ECE/TRANS/WP.29/GRE/2007/44
18 July 2007

REGULATION No. 98

Proposal for draft Supplement 10 to Regulation No. 98
(Headlamps with gas-discharge light sources)

Submitted by the expert from the Working Party "Brussels 1952"

4. P+D (DCR) with the same light source

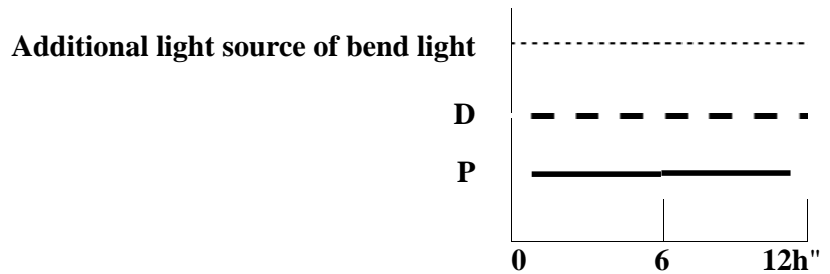
In the case of a passing beam and a driving beam provided by the same gas-discharge light source, the cycle will be:

**15 minutes, passing beam lit
5 minutes, all driving beam contributors lit**

Annex 4 – Appendix, amend to read:
